Rezoning Transportation Analysis

Petition Number: 2019-168

Date	Description
12-18-2019	First Review

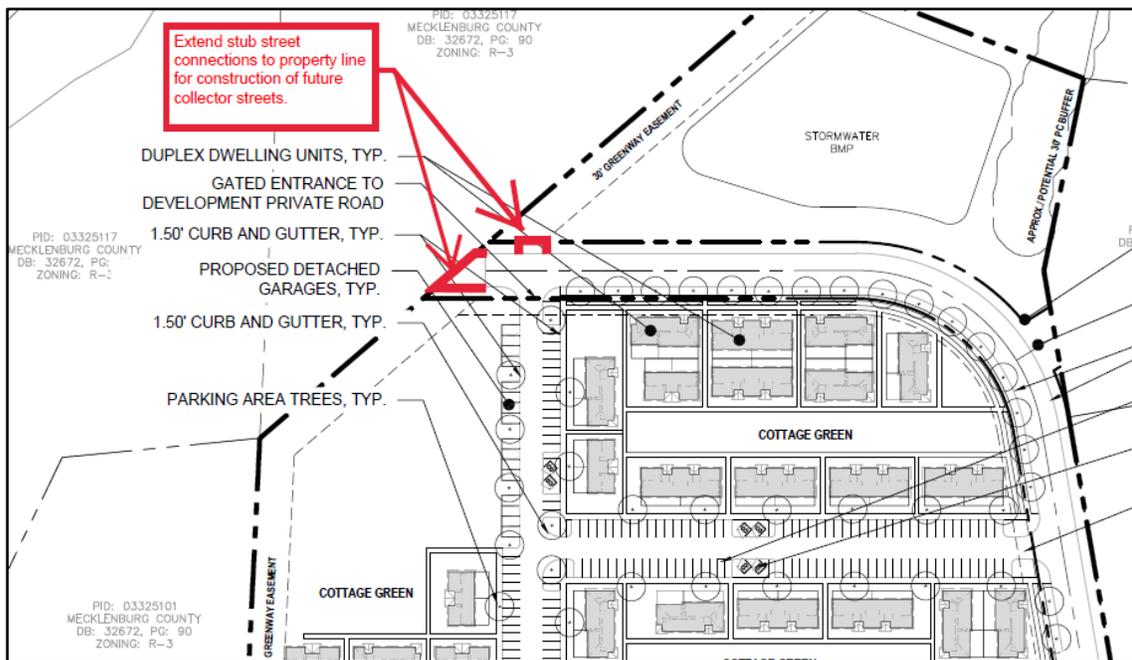
Oakdale Road (NCDOT maintained): The future location of curb and gutter is for a three-lane section. The face of the curb and gutter should be located 18.5' from center line of the road.

The site plan should show the curb and gutter labeled and dimensioned from the centerline for each road.

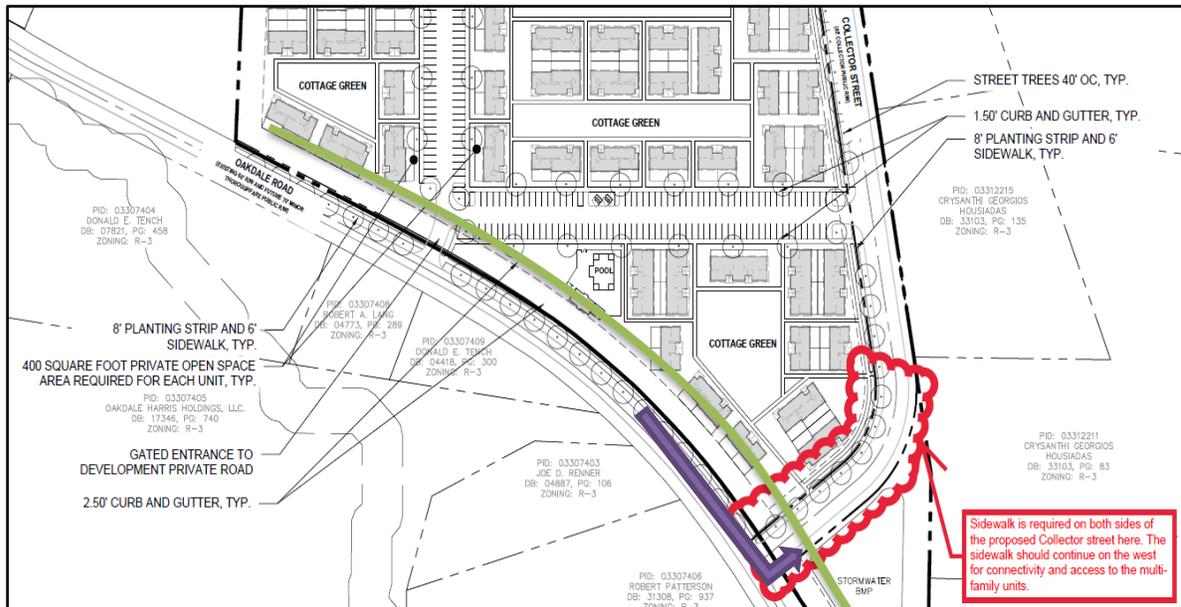
7. To comply with the council adopted Charlotte Walks and BIKE Policy, CDOT is requesting the petitioner construct a 12-foot multi-use path along the Oakdale road. See multi-use path shown above in green.

8. Per NCDOT, the petitioner should revise the site plan and conditional note(s) to include an eastbound left turn lane from Oakdale onto the proposed Collector street. See left turn lane shown above in purple.

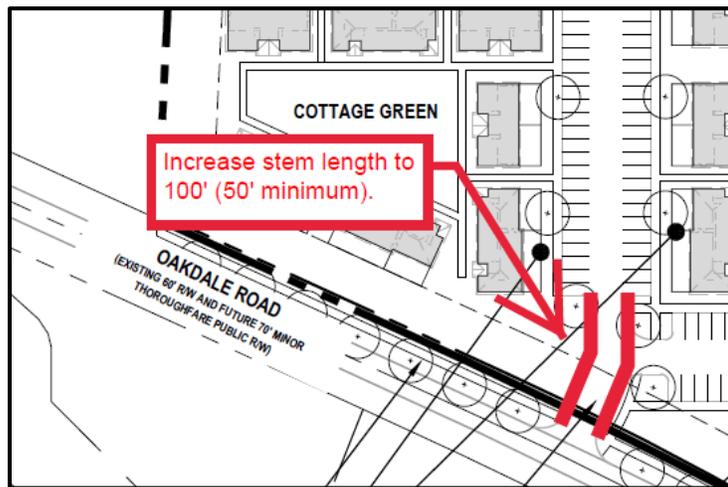
10. Per NCDOT, the proposed driveway stem length should be extended to 100' to ensure proper circulation of traffic and mitigate queuing onto Oakdale Road. In addition, if a gate will be provided, then a turnaround should be provided to the access to Oakdale Road because of the road traffic.

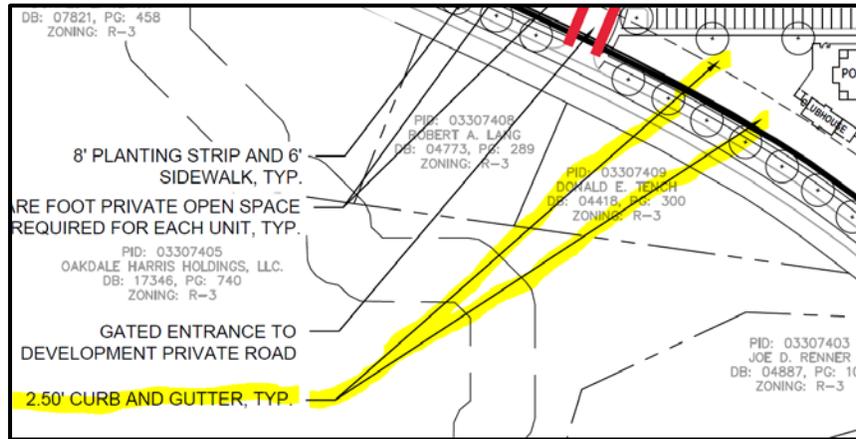
11. The petitioner should revise the site plan and conditional notes to correctly show label the curb and gutter locations on the site plan. The site plan is showing a label of curb and gutter that is pointing to where there is not curb and gutter.
